ADDENDUM

PROJECT NAME: Our Lady of Perpetual Help – Barrier Free Elevator Expansion

ADDENDUM NO.: PTA-E-01

1.1 Drawings E001, E002, E003, E004, E100, ED100 (Attached)

1 SECTION DETAIL OF FOUNDATION WALL ALONG GRIDLINE -1
N.T.S.

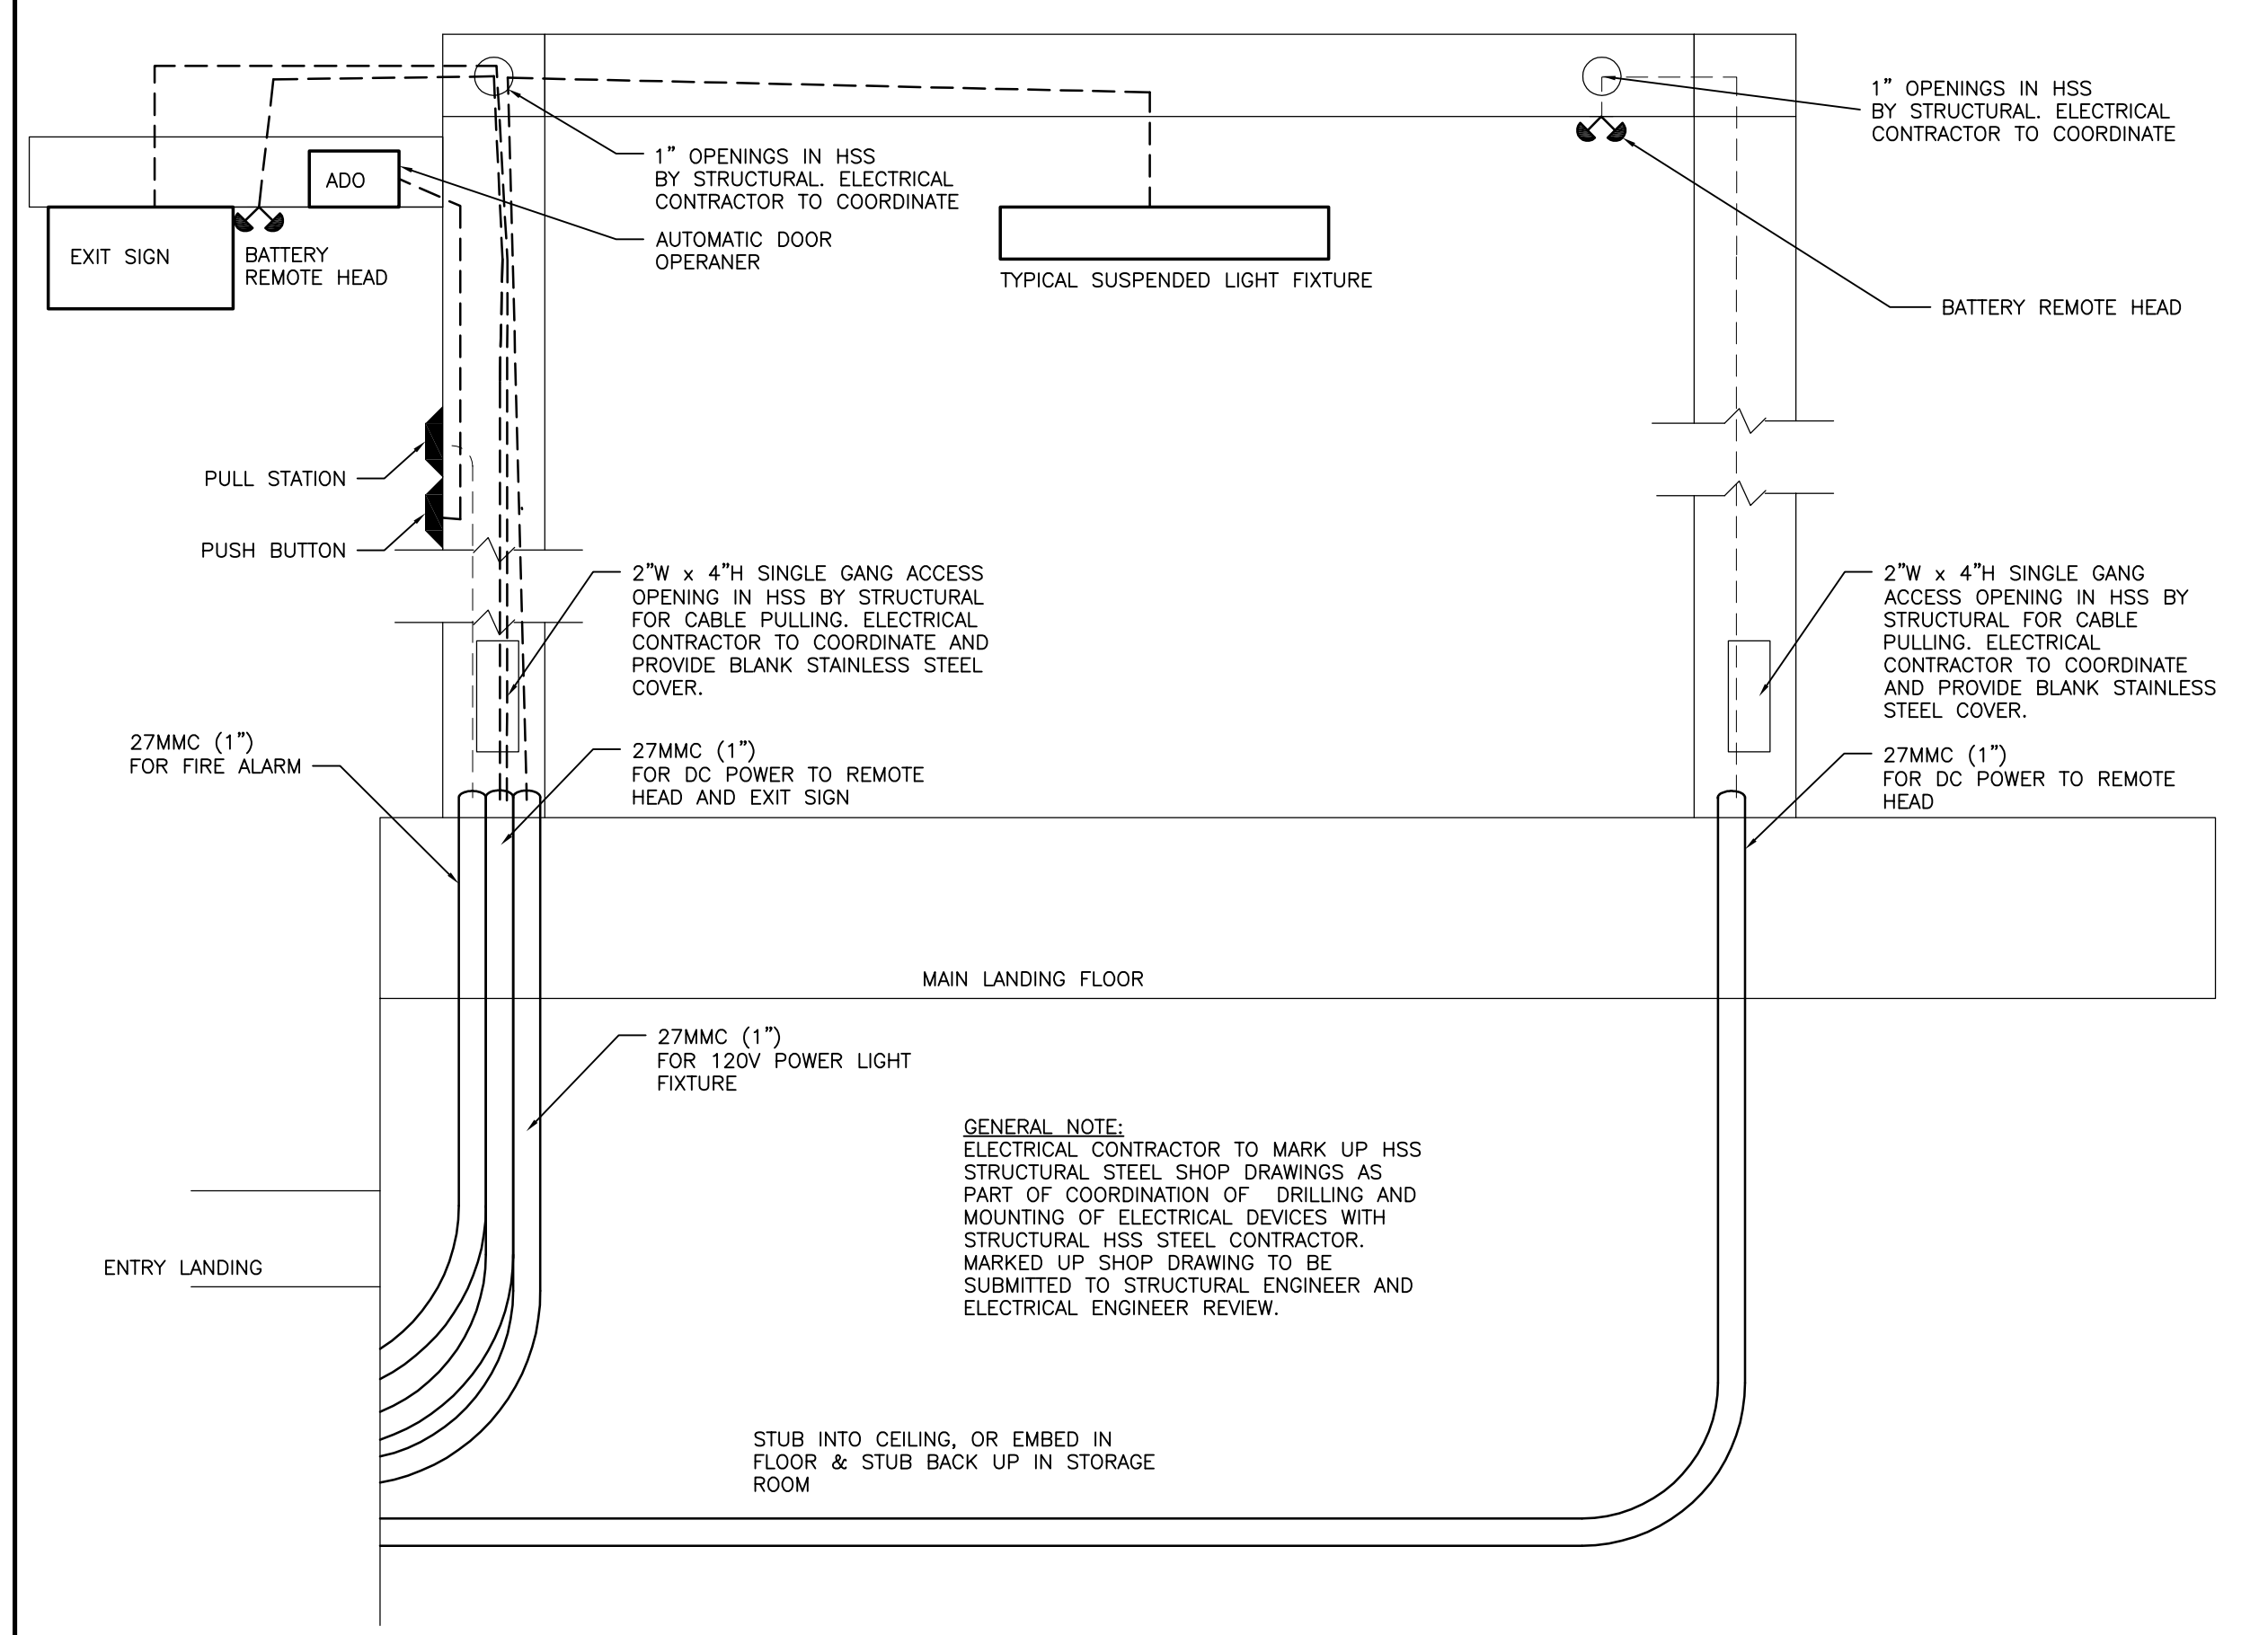
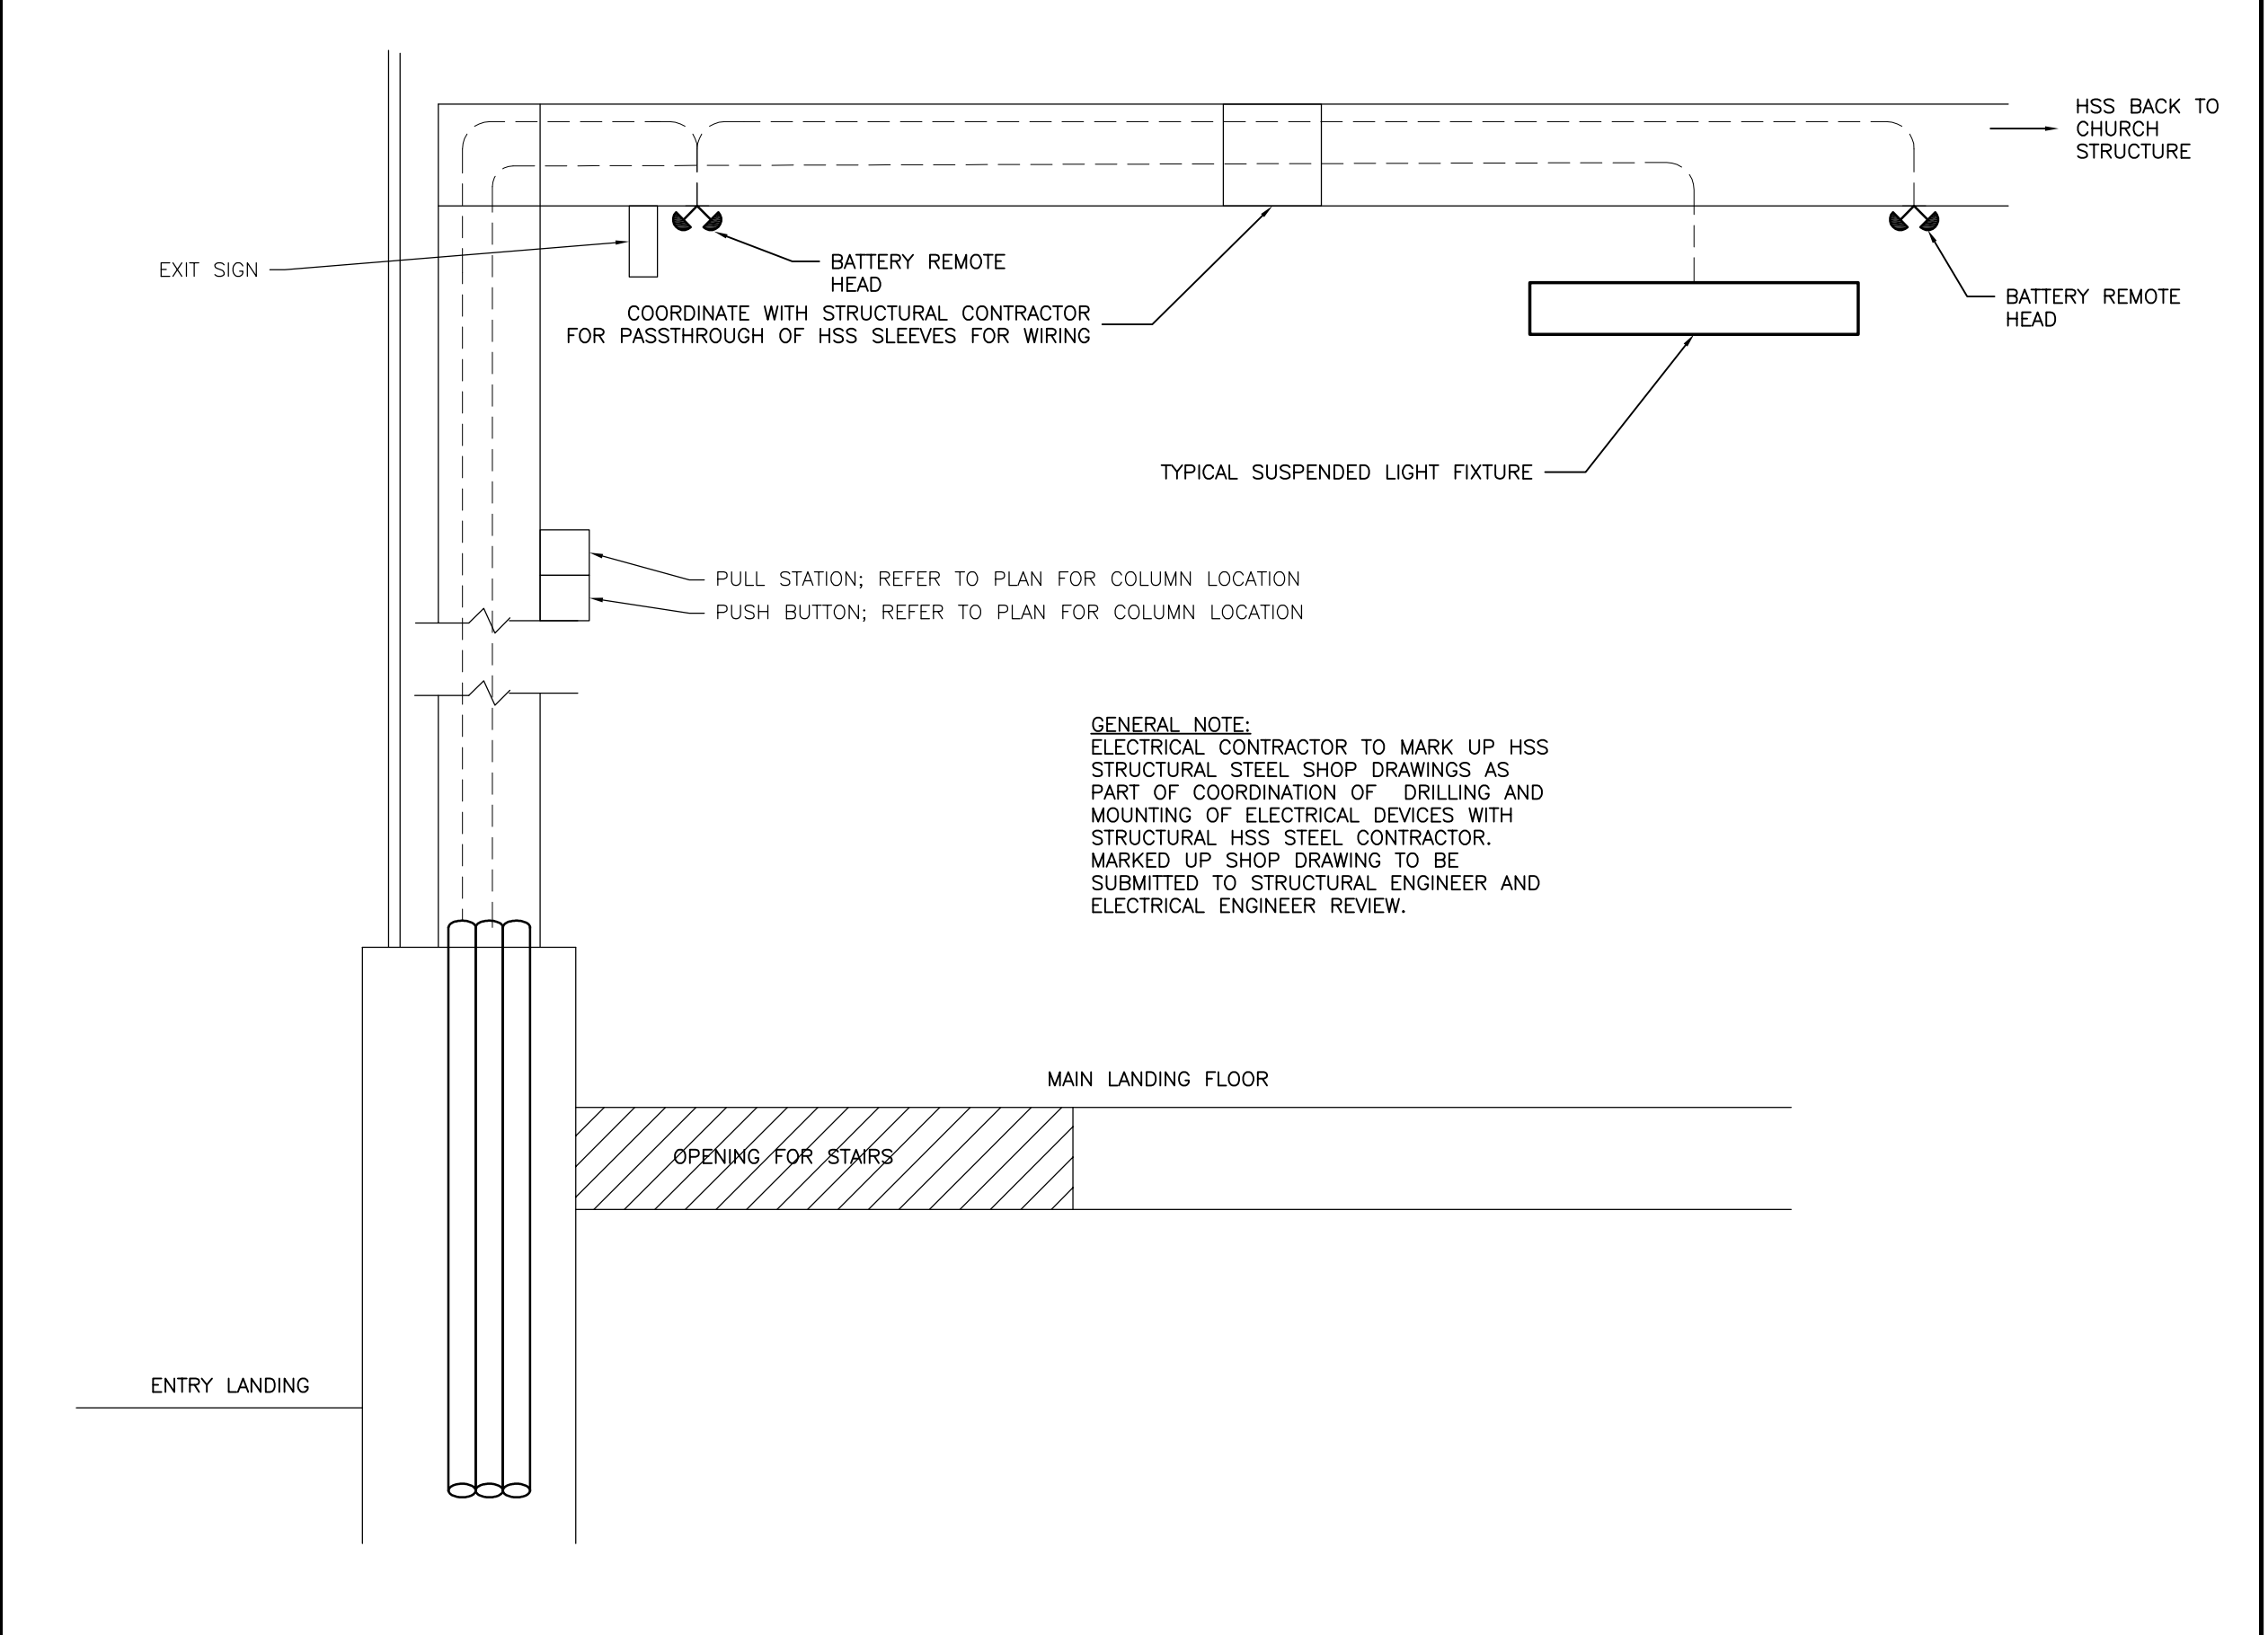
2.2 E002

2.2.1 Revise general intent of raceway routing through HSS as shown.
